CONTRACT CHANGE ORDER MEMORANDUM

TO: DEANNA VILCHECK / JEANNETTE BALDERRAMOS			FILE: E.A. 04 - 0120M4
FROM: JEANNETTE BALDERRAMOS			CO-RTE-PM 04-ALA-80-1.6/2.7
			FED. NO. NO FED AID
CCO#	SUPPLEMENT#:	Category Code:	CONTINGENCY BALANCE (incl. this change)
1	0	AJZZ	\$5,079,361.00
COST: \$250,000.00		INCREASE <input checked="" type="checkbox"/> DECREASE <input type="checkbox"/>	HEADQUARTERS APPROVAL REQUIRED? <input type="checkbox"/> YES <input checked="" type="checkbox"/> NO
SUPPLEMENTAL FUNDS PROVIDED: \$250,000.00		IS THIS REQUEST IN ACCORDANCE WITH ENVIRONMENTAL DOCUMENTS? <input checked="" type="checkbox"/> YES <input type="checkbox"/> NO	
CCO DESCRIPTION: Flagging & Traffic Control			PROJECT DESCRIPTION: CONSTRUCT BRIDGES AND ROADWAY, AND ELECTRICAL SYSTEM
Original Contract Time:	Time Adj. This Change:	Previously Approved CCO Time Adjustments:	Percentage Time Adjusted: (including this change)
1140 Day(s)	0 Day(s)	0 Day(s)	0 %

CCO DESCRIPTION: Dispute Review Board (Caltrans Portion)		PROJECT DESCRIPTION: CONSTRUCT BRIDGES AND ROADWAY, AND ELECTRICAL SYSTEM		
Original Contract Time: 1140 Day(s)	Time Adj. This Change: 0 Day(s)	Previously Approved CCO Time Adjustments: 0 Day(s)	P

CONTRACT NO. 04-0120M4
 CONTRACT CHANGE ORDER NO. 23
 SHEET 4 OF 13

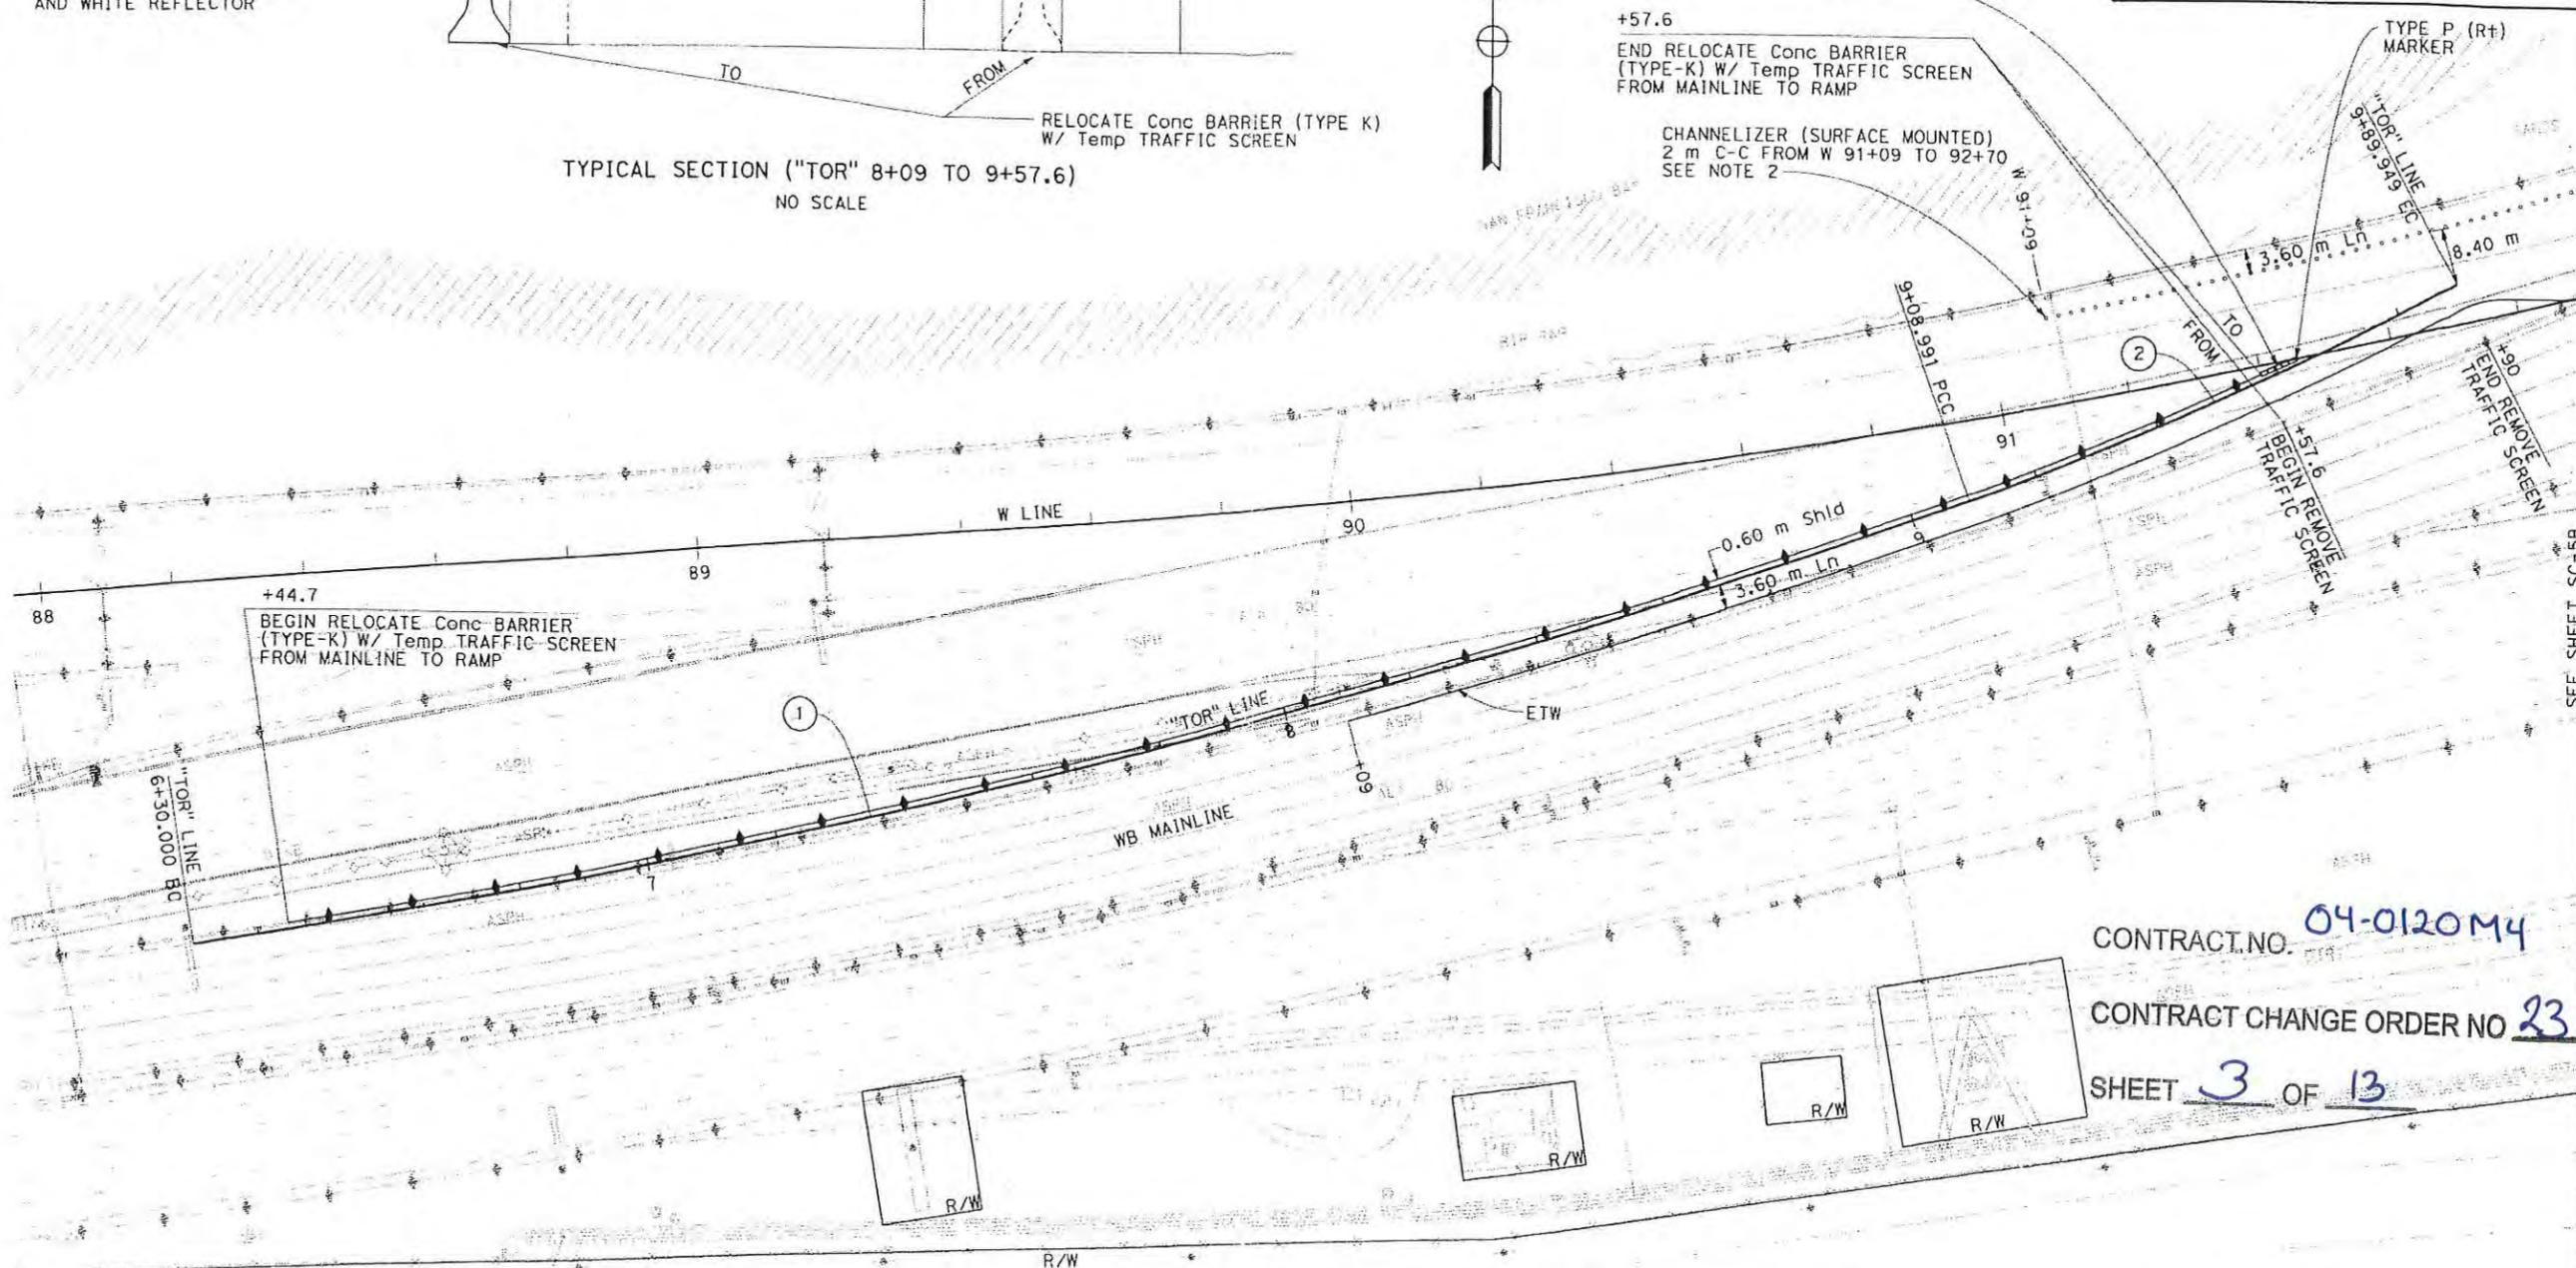
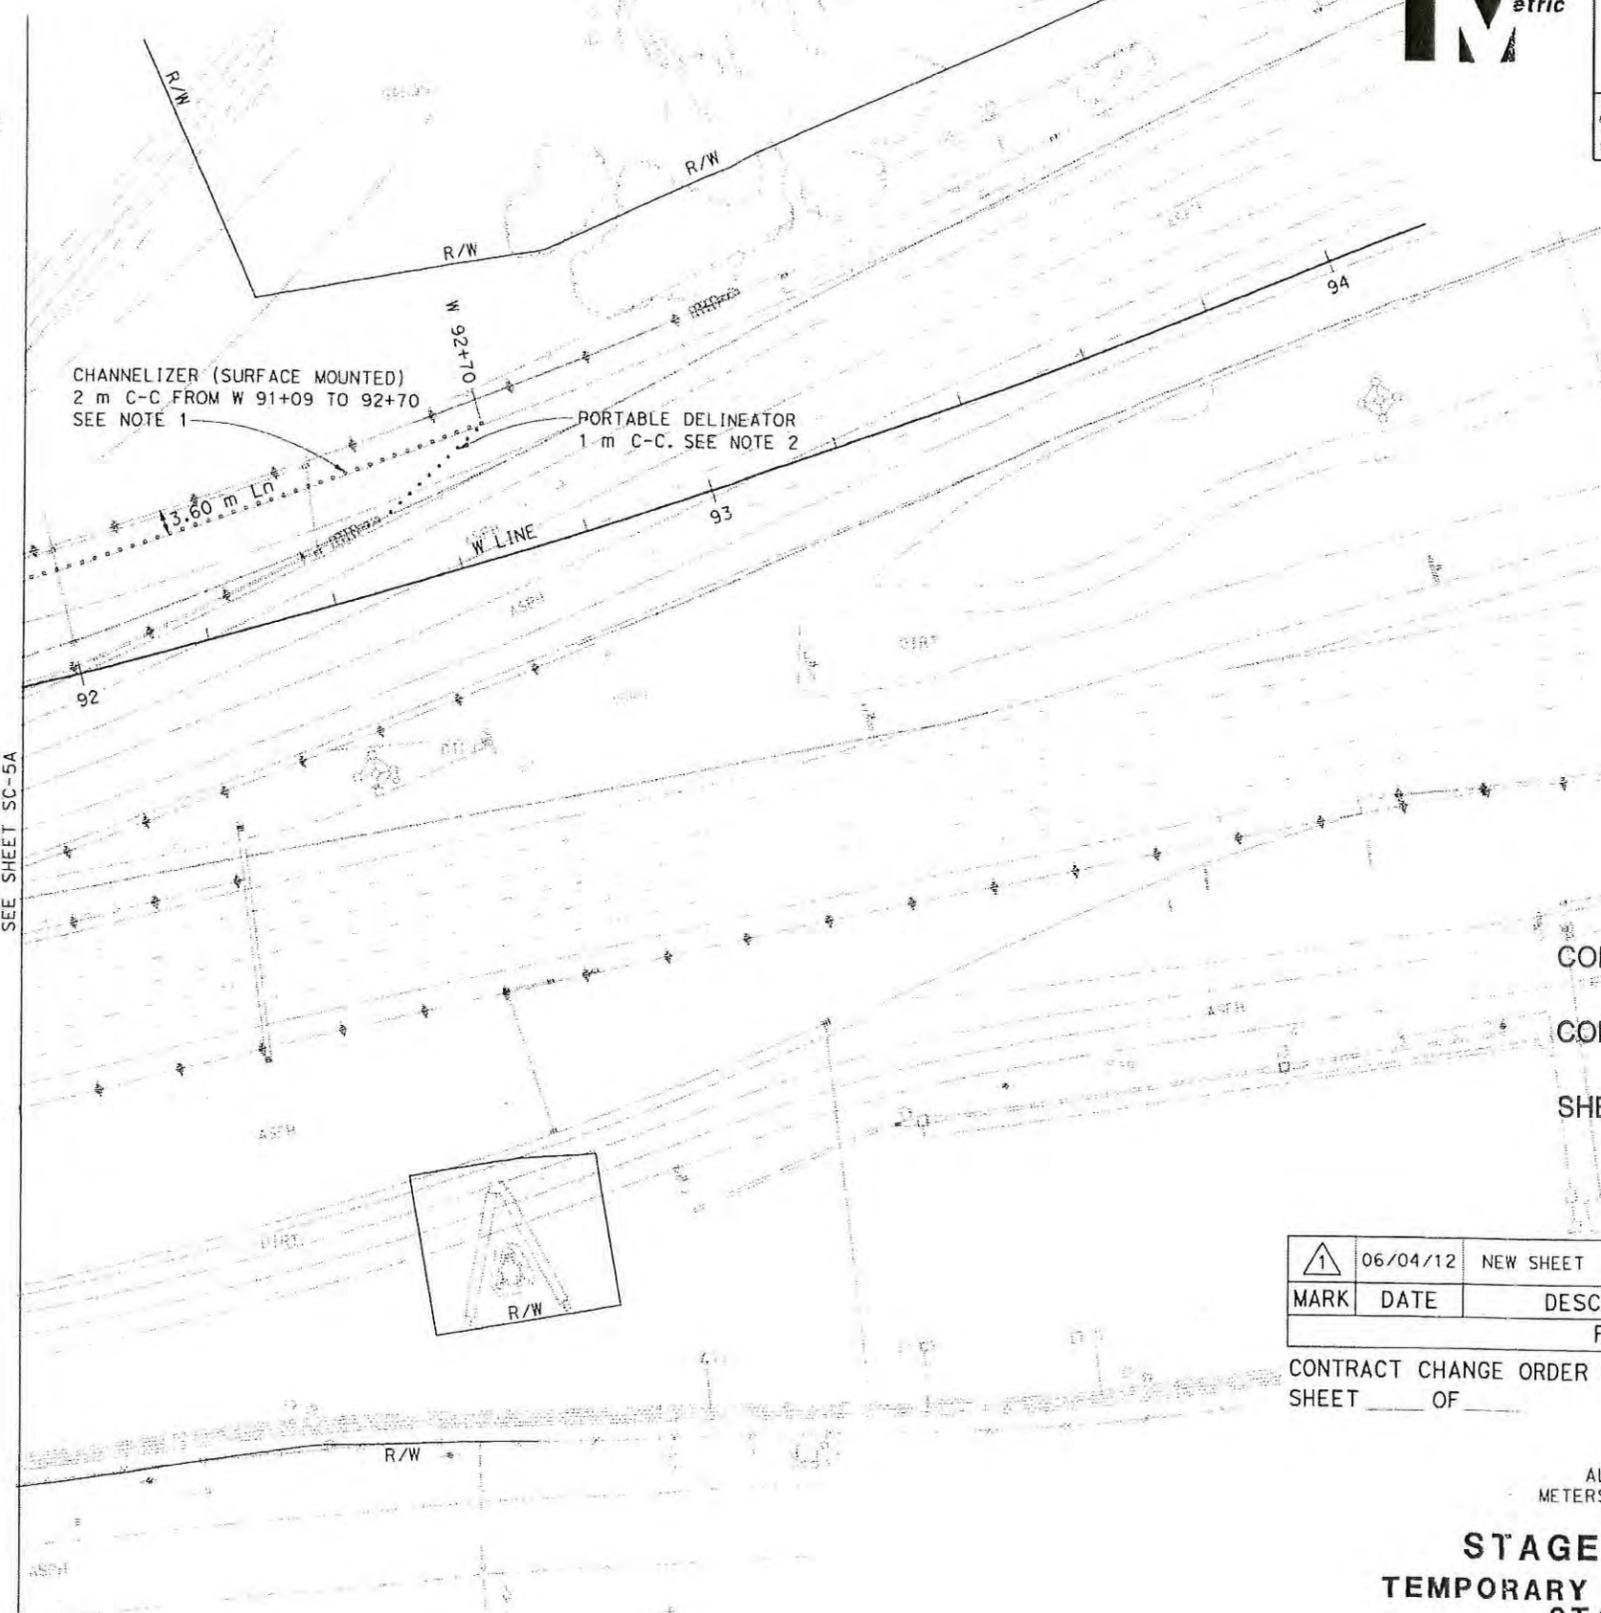
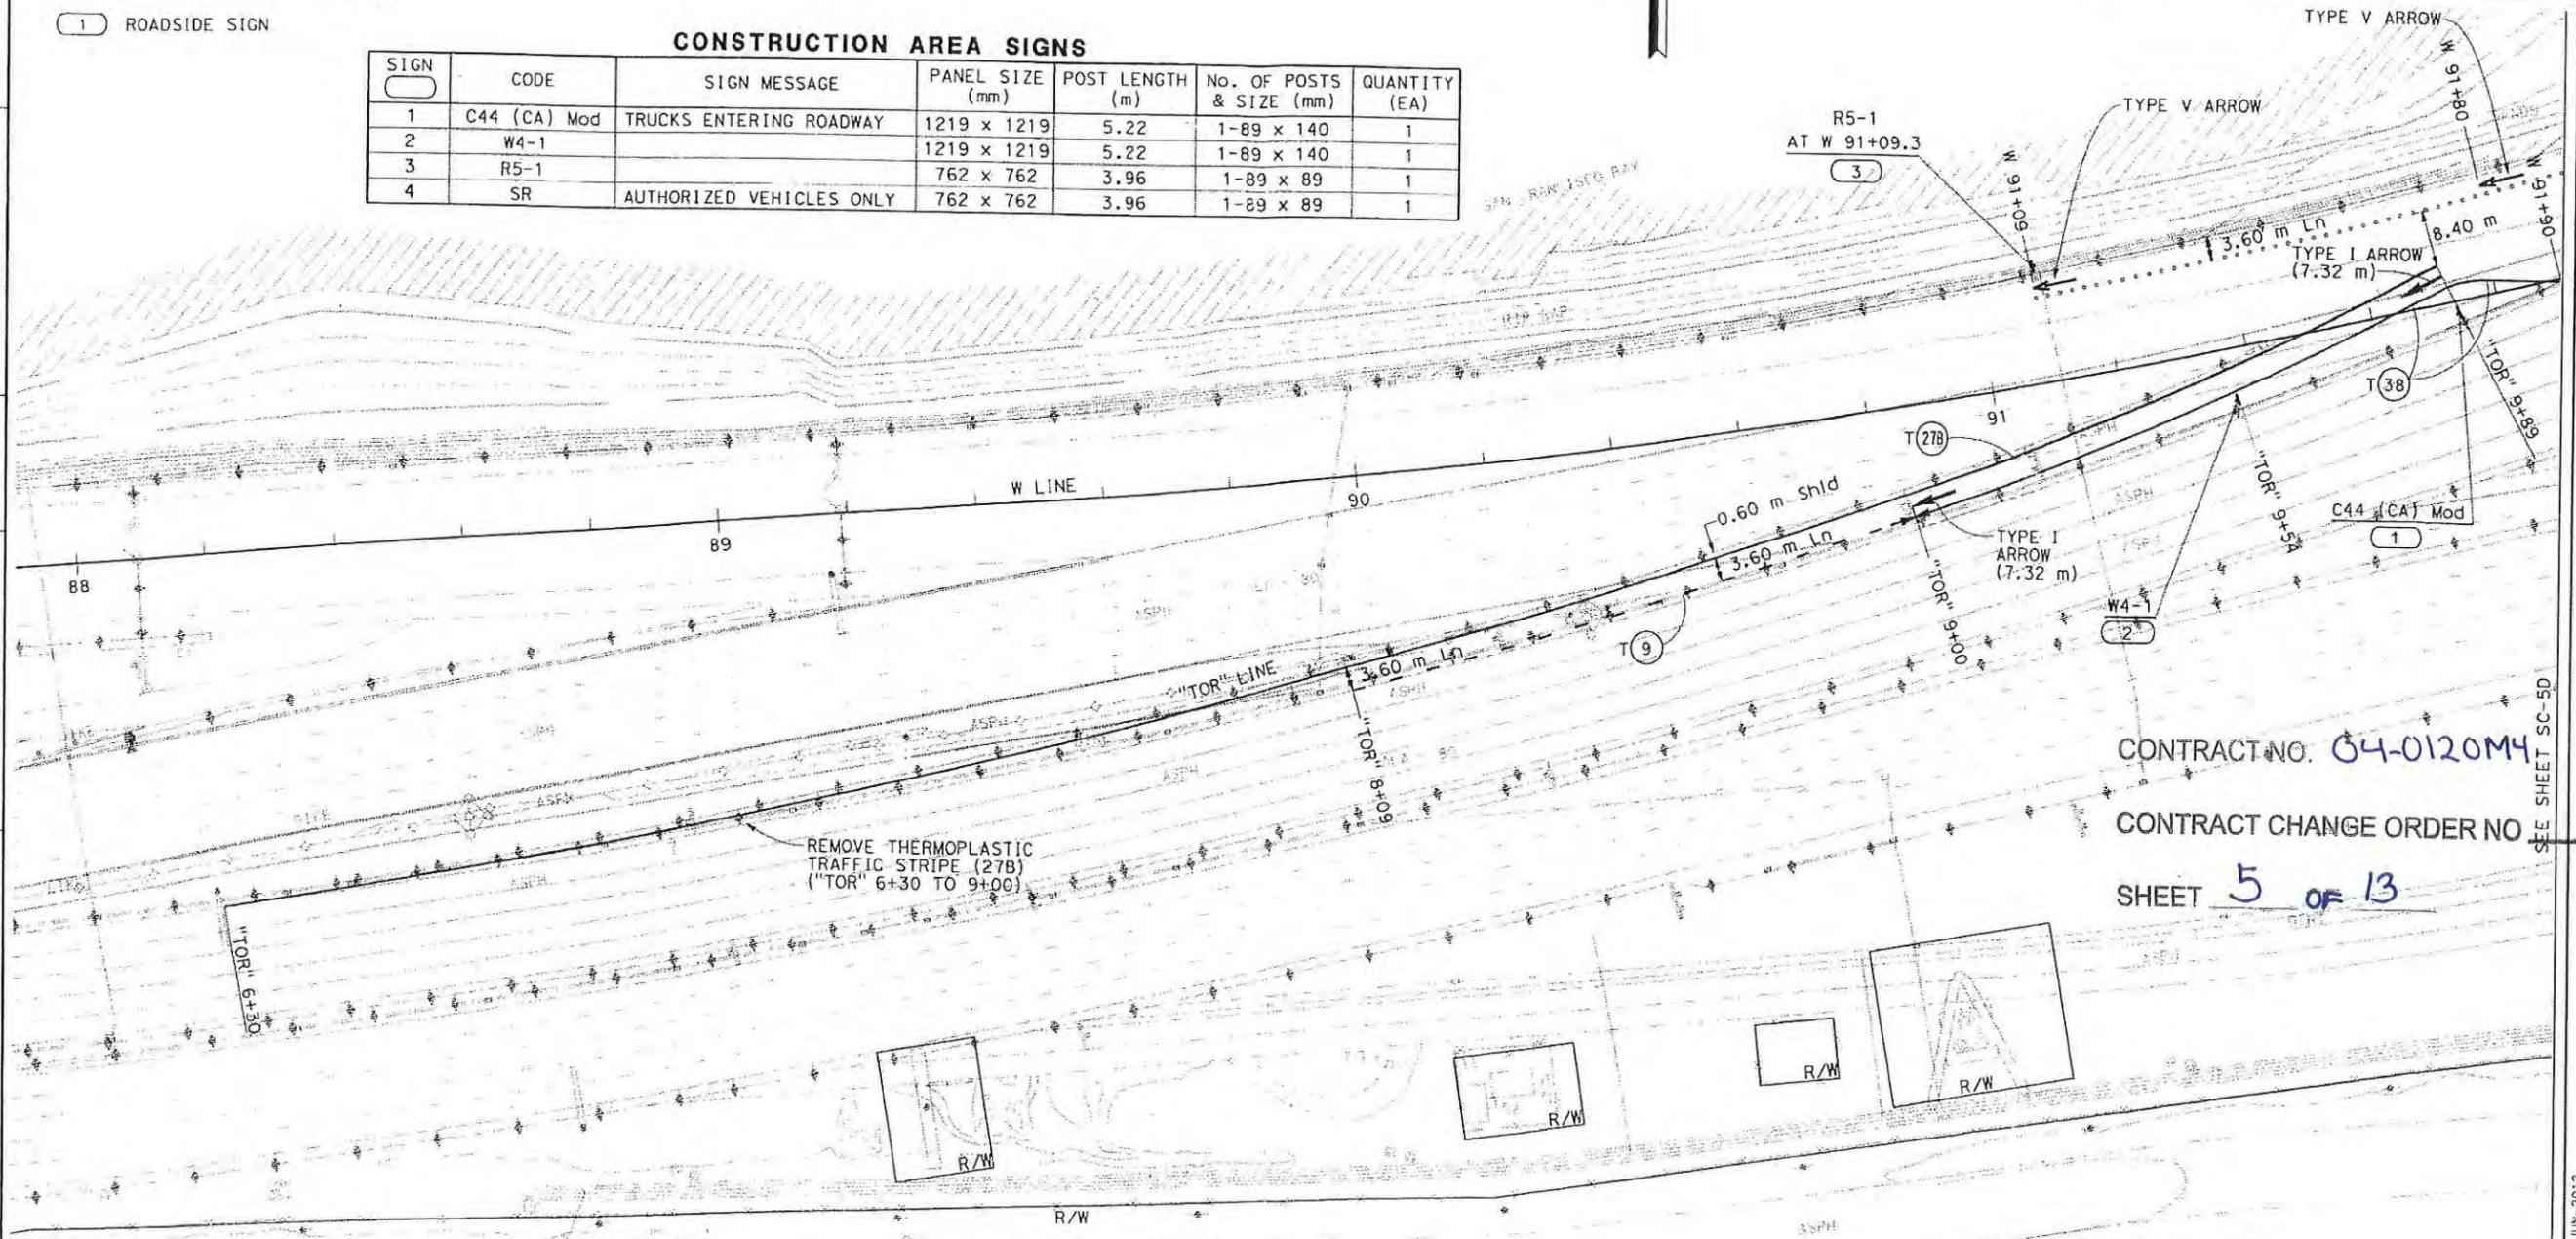
Construct the access merge lane from the construction site to Westbound I-80, as shown on contract plan sheets 110A, 110B, 110C, 110D, and 131R1, sheets 3 through 7 of this change order.
